# Crown Fashion & Sweater Ind. Ltd. Crown Knitwear Ltd. (Building 3)

Plot 781/782, Vogra, Joydevpur, Gazipur.  
(23.982841, 90.38177)  
02 April 2014

# Executive Summary (continued)

## High Stress in Columns

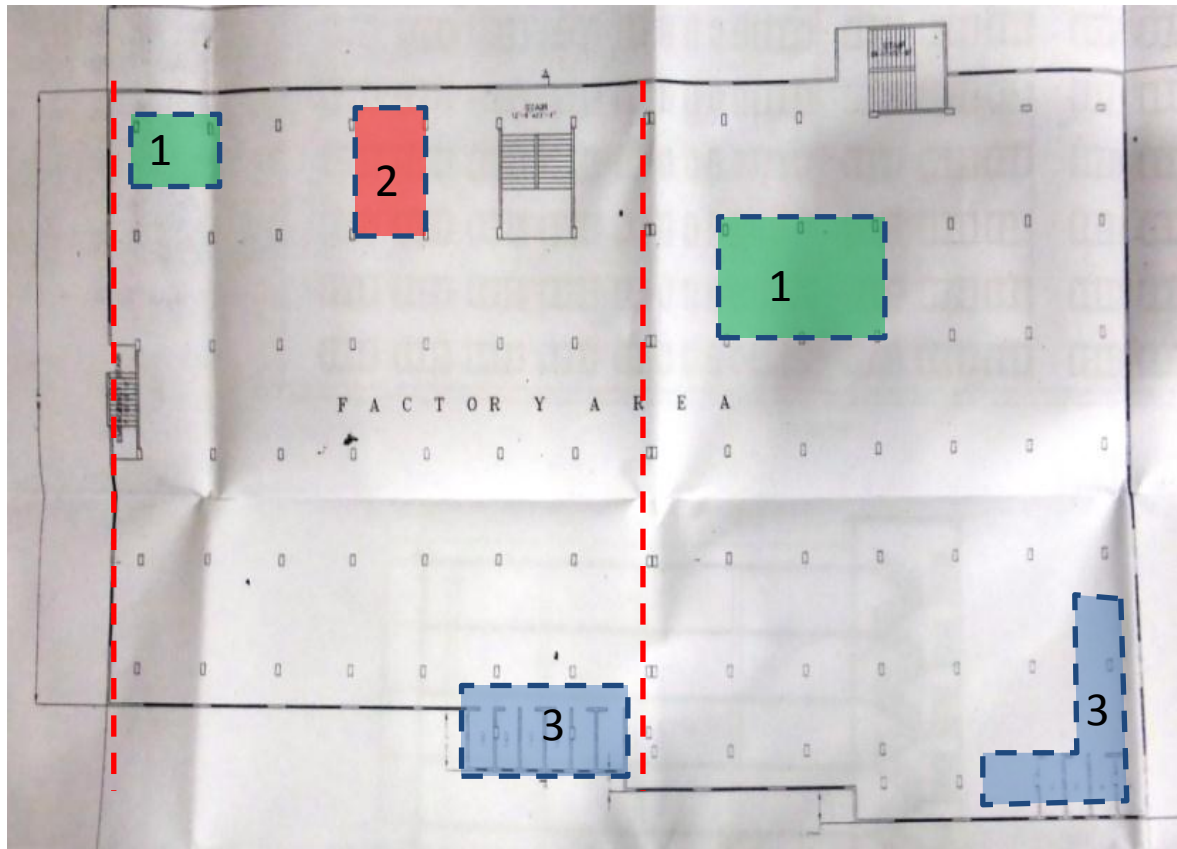
**Tested column  
at ground level.  
Brick aggregate  
observed.**

Preliminary calculations indicate that some internal and external column working stresses are at a high level.

Engineer is to perform detailed calculations based on as-constructed dimensions and concrete tests to prove column size is adequate.

Scanned reinforcement observed to be less than specified on the engineering drawings.

A Detailed Engineering Assessment is required (see attached Scope) along with Buildings 1, 2 & 4 as outlined in previous report.

**Water Tank locations at roof level and storage of aggregate.**

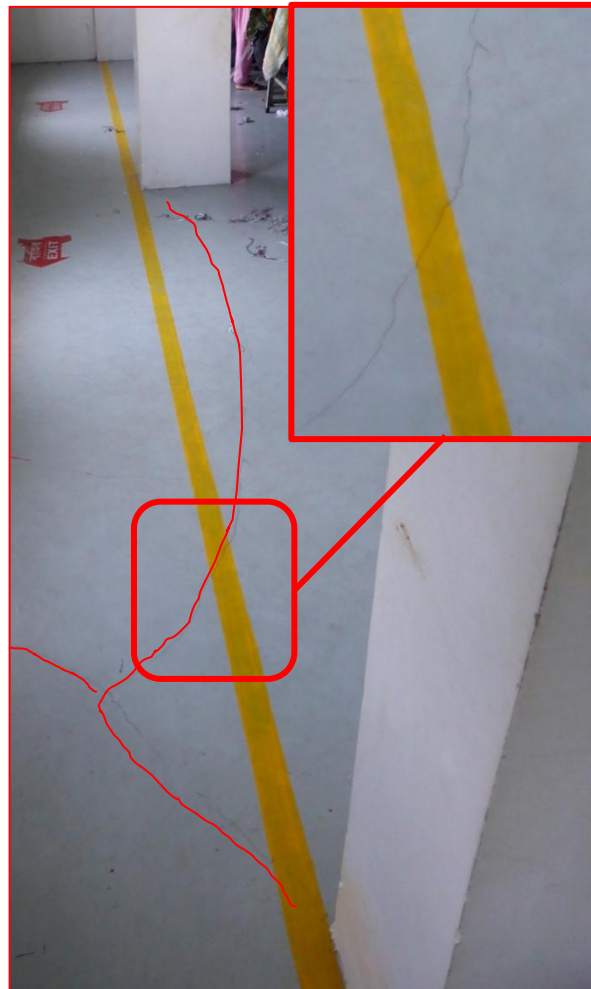
Areas were observed with higher than typical loading in the building, including:

1. Water tanks at roof level
2. Storage loading
3. Increased build-ups in toilet blocks at all levels

Storage loading and increased build-ups were observed in a number of other areas, including storage of brick aggregate at roof level.

Flat slab – 5<sup>th</sup>  
(part), 6<sup>th</sup> and  
Roof floors

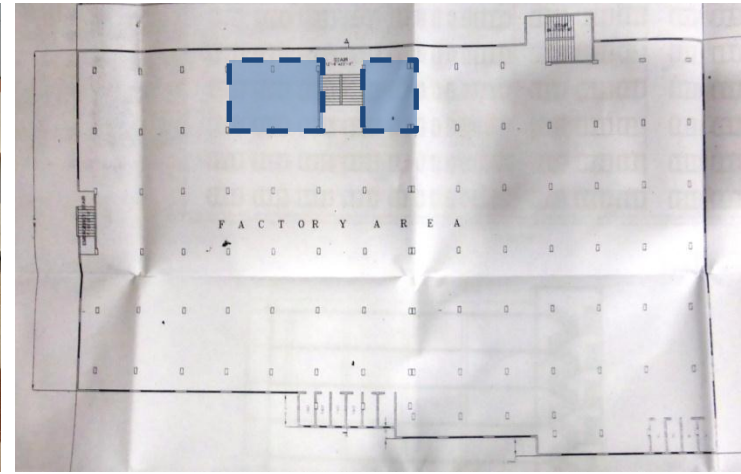
The change in structural system could indicate that Building 3 may have been constructed in a number of phases both horizontally and vertically, contradicting the information given at the Manager Interview that the building was constructed in one phase in 2003.

Drawings indicate a beam and slab construction at all floors.

Building Engineer should check that lateral stability is maintained through the two structural systems.
